June 22, 2020 · Agenda

I. Public Hearings - Old Conway Design Overlay District

Sign Exception Review

New Single-Family Residence

ELEVATIONS	ALLISON HOME CONWAY, ARKANSAS	HURD LONG Architects & Design Consultants, P.A. <small>101 Fox Mobile Street • Little Rock, Arkansas 72019 • 501.726.4477</small>
		PROJECT NO. _____ DATE _____ SHEET NO. A-3

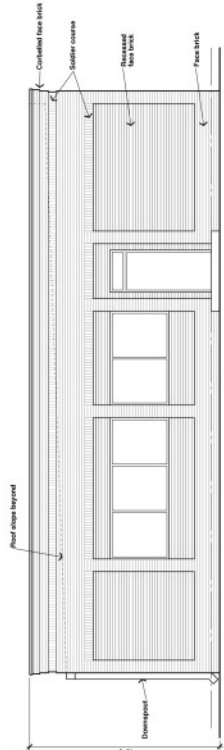
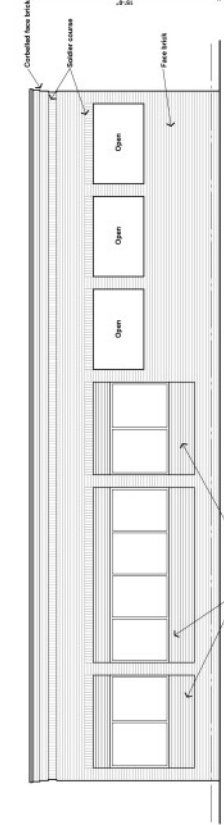
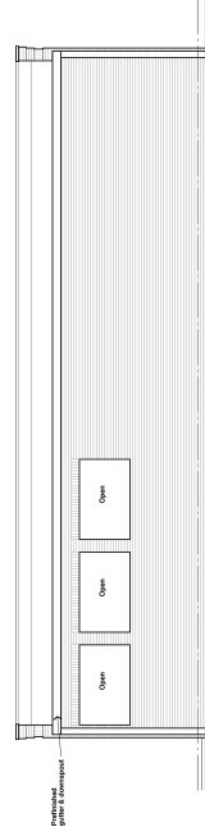
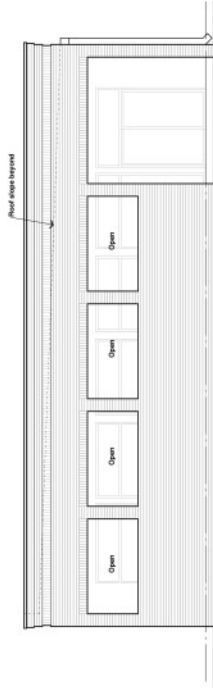
Staff interprets this provision to primarily toward façades facing a street or sidewalk. The north façade shall have 25% windows (visible from Chestnut St), east façade - 16%, west façade - 32% (facing alley), south façade - 11%. All these windows are placed between 4-6 feet above the ground.

Recommend requiring windows on the east and north façades be lowered to at or near 4 feet above the ground and increased in size. Opaque glazing may be used on all windows (CURRENTLY INDICATED ON PLANS)

1. Require 3 understory trees and 6 shrubs as indicated on the applicant's site plan.
2. Require any major utility equipment be placed or screened in a manner to ensure it is not viewable from the street or sidewalk.
3. Require windows on the east and north façades be lowered to at or near 4 feet above the ground. Opaque glazing may be used on all windows.
4. The applicant will provide revised and corrected plans to the Planning Director for review and approval prior to issuance of building permits, if necessary.

RETAIL CENTER
ELEVATIONS
A3.3

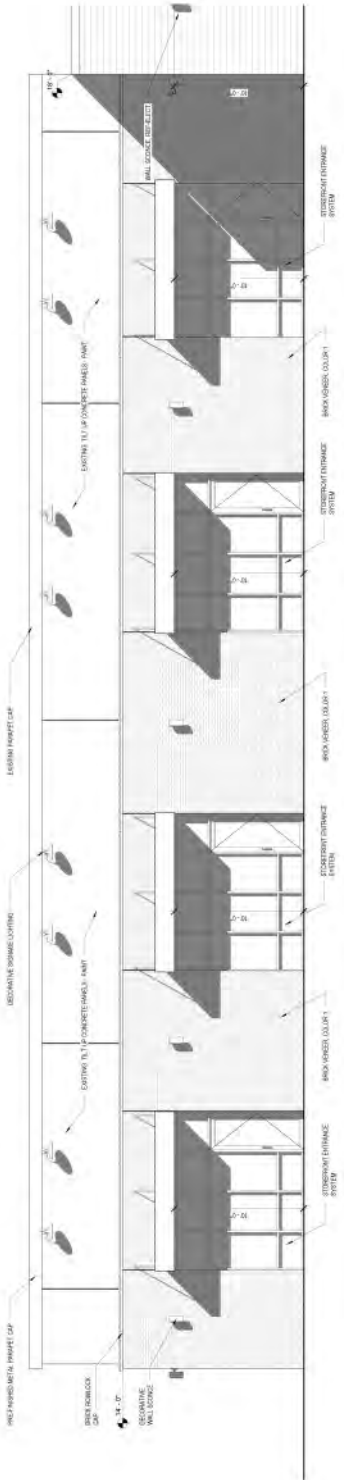
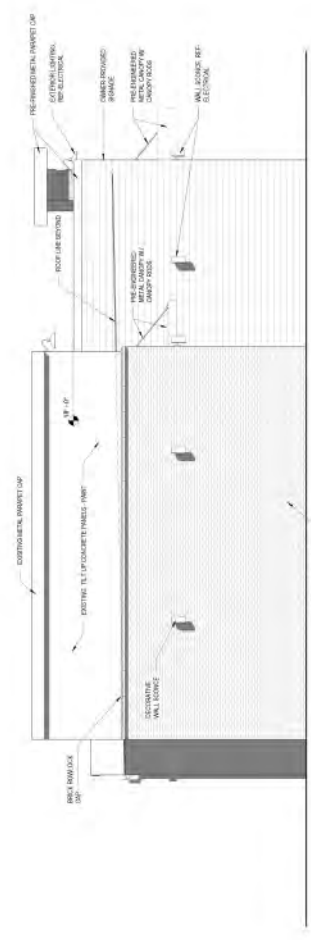
The proposed façades are compatible with the surrounding area. 23% of the front façade's area is devoted to windows and openings.

The proposed materials are existing concrete panels and brick. The proposed materials are appropriate

Roof forms and materials are appropriate. The applicant is proposing a flat roof design.

Staff recommends approval of the commercial building façade change with the following conditions:

1. The property shall be replatted to eliminate any setback encroachments.
2. The site shall be subject to the Development Review process.
3. The sidewalks along Harkrider St shall remain in place and shall be replatted/repared if damaged during construction.

4. A landscaping plan, demonstrating compliance with the landscaping requirements of Section 1101 of the Zoning Code shall be submitted and approved by the Director of Planning. This shall include one canopy tree planted every 30 feet of street frontage with additional shrubs and other plantings throughout. Additionally, one landscape island shall be required at the end of all parking rows.

5. No additional access to Harkrider St shall be granted.
6. HVAC equipment be placed in a manner to minimize its visibility from the street.
7. The applicant will provide revised plans to the Planning Director for review and approval prior to issuance of building permits.

SITE PLAN
1"=20'

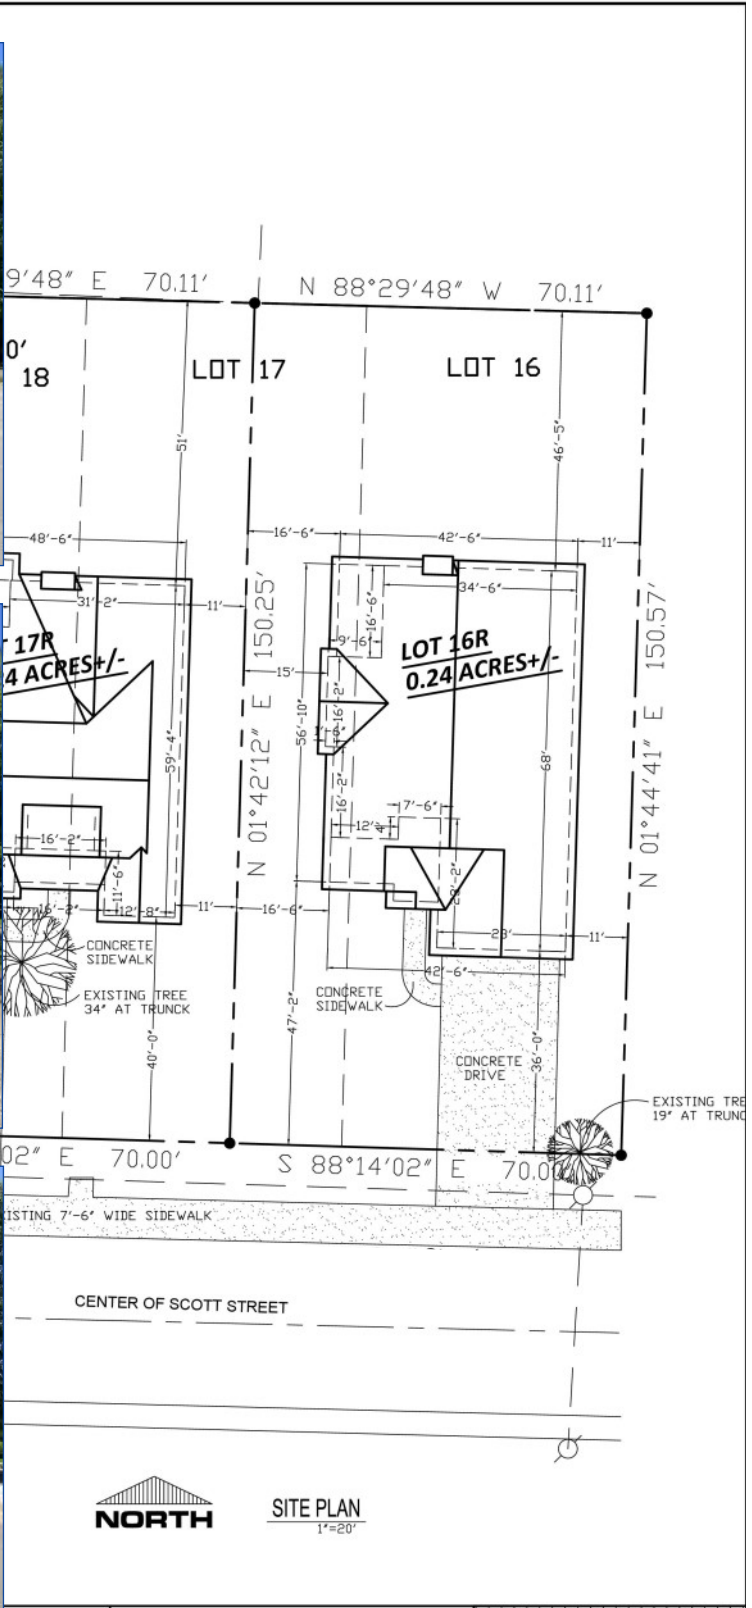
The proposed front setback is not appropriate. An appropriate front setback would range between 44' and 60'. Given the limited number of structures, matching the setback of the property directly to the west is preferable. Only two structures exist on the north side of the block due to a recent demolition. Therefore, spacing relationships can't be established.

The proposed garage is placed at the front of the structure and does not meet the requirements of the regulations.

The applicant is proposing a 21' driveway with available parking in front of the house. This does not meet the intent of the regulations and would result in the parking not meeting the requirements of the regulations.

There is an existing 19" diameter tree in the front yard. The proposed driveway location would likely cause damage to the tree due to encroachment within the drip line. One additional canopy trees is required and improvements on the site should be moved in a manner to prevent harm to the existing tree.

Staff recommends the application be tabled for revisions by the applicant. The application cannot meet the requirements of the regulations as currently, designed.

1. Front setback does not meet requirements.
2. Garage location is not appropriate.
3. Driveway is too wide and front parking is not permitted.
4. Recommend requiring front walkway.
5. Indicate proposed fencing locations.
6. Driveway should be located in a manner to prevent harm to the existing 19" tree.
7. The front façade should be redesigned to make the front porch and front door the focal point and contain additional windows in a manner more similar to the surrounding area (particularly remove the front garage).

FRONT ELEVATION

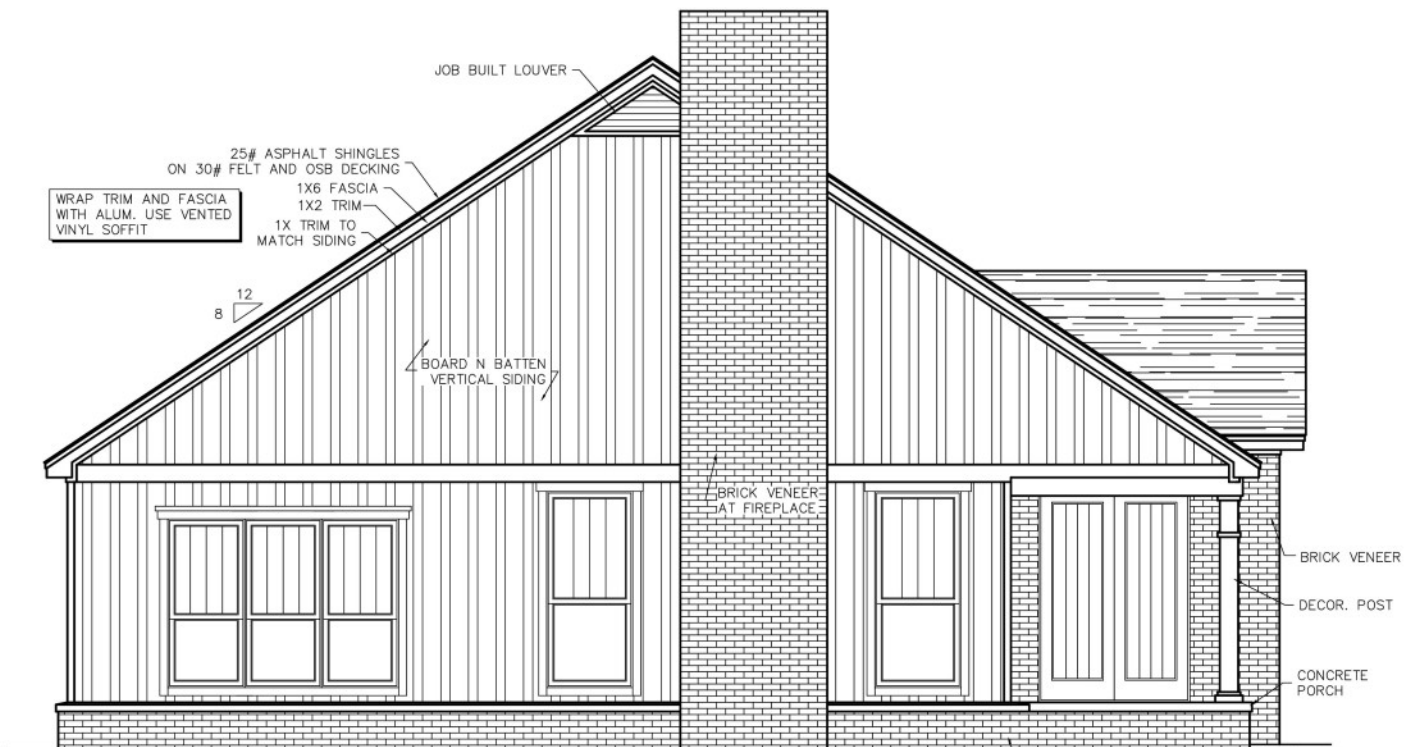
The front façade will be composed of 13% windows/openings. The presence of a front garage helps create a large blank area that is not compatible with the intent of the regulations.

The surrounding area does not have a cohesive theme of styles, mixing traditional, historic vernacular, and contemporary elements. However, the presentation of the elements on the house is not compatible with the overall area, namely the recessing of the front porch behind the garage.

An open front porch with a varying depth of 8'-15' depth is proposed. However, this porch is recessed such that it is not the primary focal point. Additionally, the front is deeply recessed within the porch. Limited details are provided on the type of windows intended. If vinyl windows are intended, faux muntins are not permitted.

FRONT ELEVATION

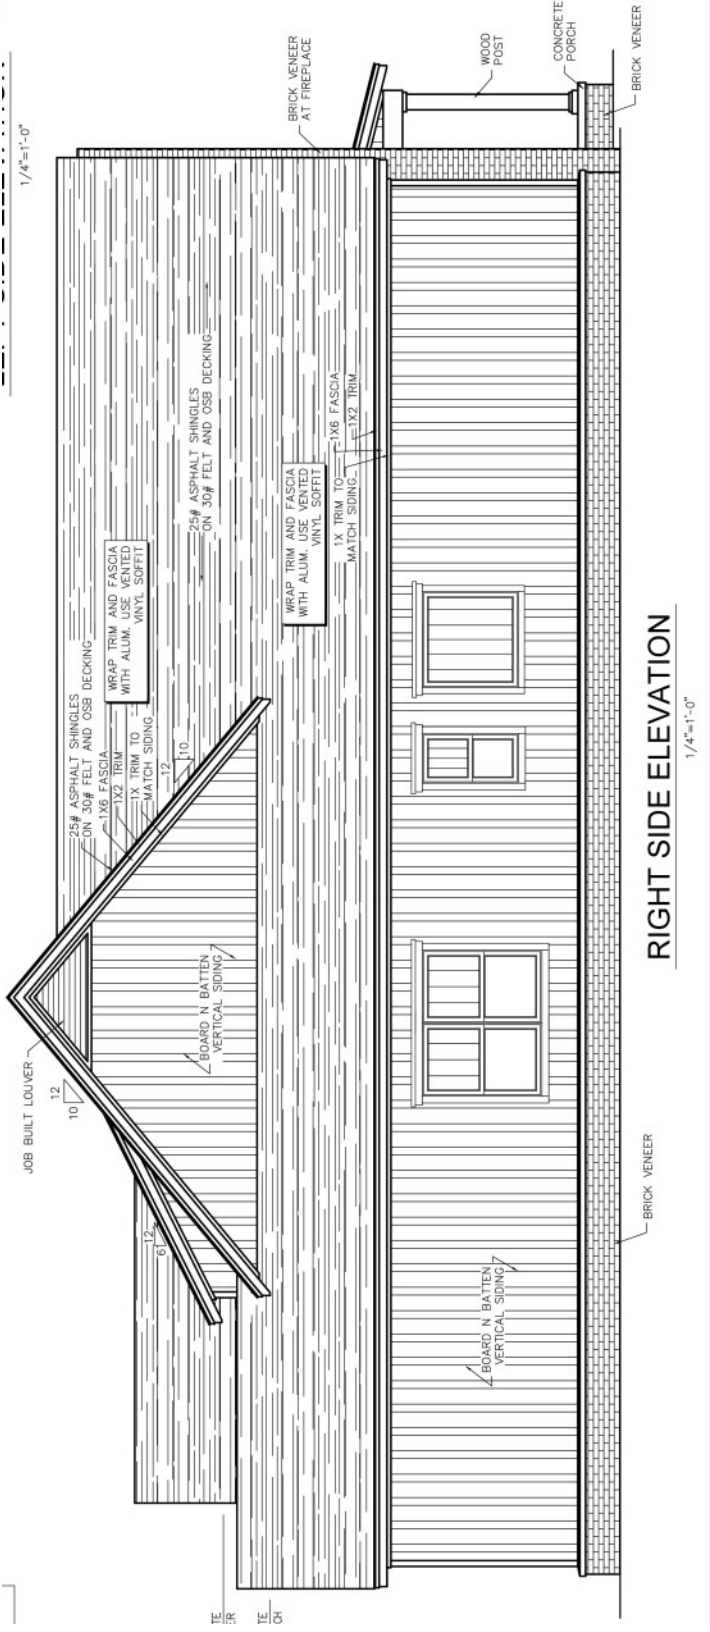
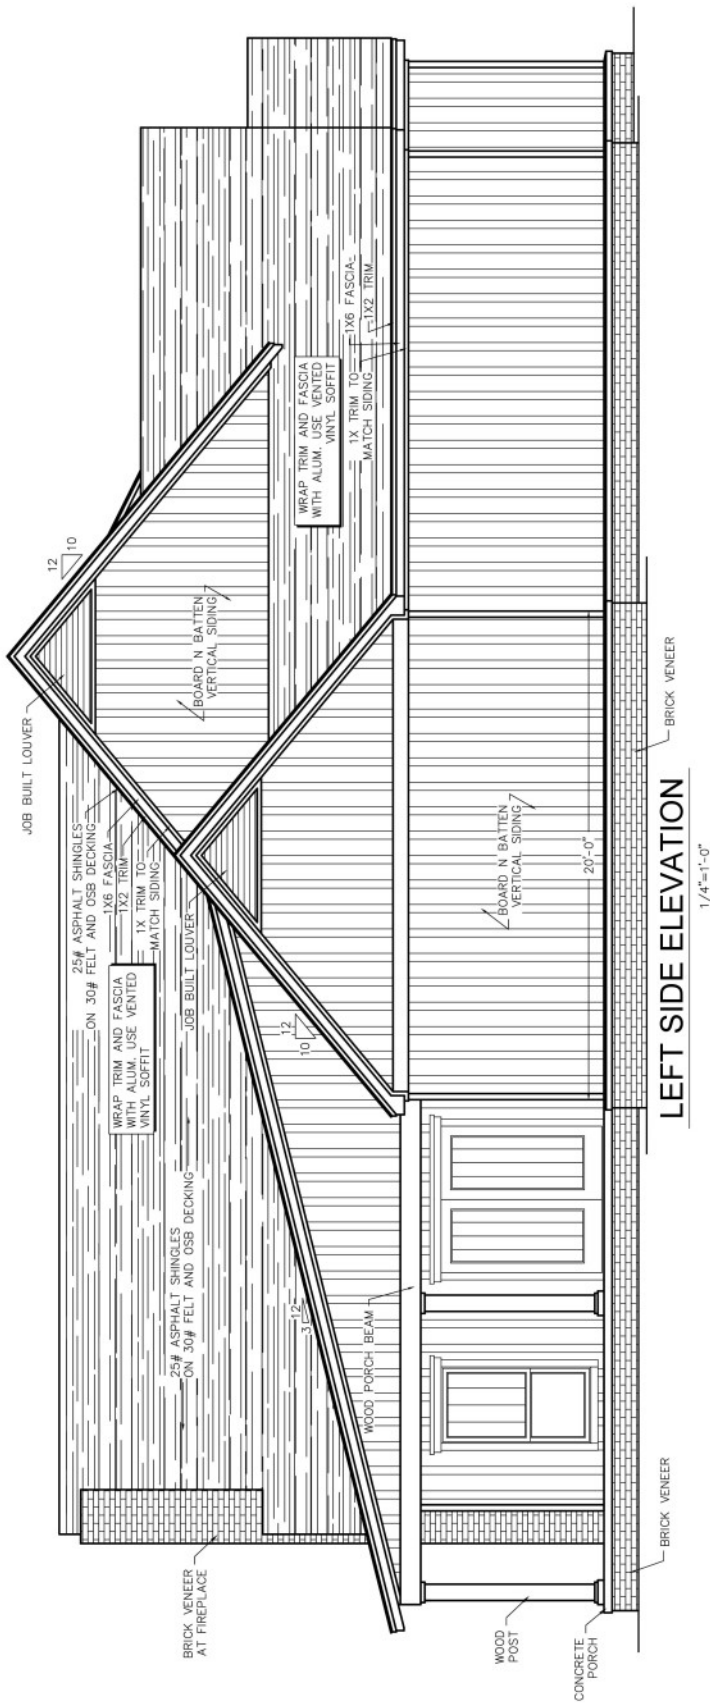
The front façade will be composed of 16% windows/openings. The presence of a front garage helps create a large blank area that is not compatible with the intent of the regulations.

The surrounding area does not have a cohesive theme of styles, mixing traditional, historic vernacular, and contemporary elements. However, the presentation of the elements on the house is not compatible with the overall area, namely the recessing of the front porch behind the garage and bedroom extensions.

An open front porch with a depth of 6' depth is proposed. However, this porch is recessed such that it is not the primary focal point. Limited details are provided on the type of windows intended. If vinyl windows are intended, faux muntins are not permitted.

1. Front setback does not meet requirements.
2. Garage location is not appropriate.
3. Driveway is too wide and front parking is not permitted.
4. Recommend requiring front walkway.
5. Indicate proposed fencing locations.
6. Structure should be designed and located in a manner to prevent removal of the existing 34" tree.
7. The front façade should be redesigned to make the front porch the focal point and contain additional windows in a manner more similar to the surrounding area (particularly remove the front garage).
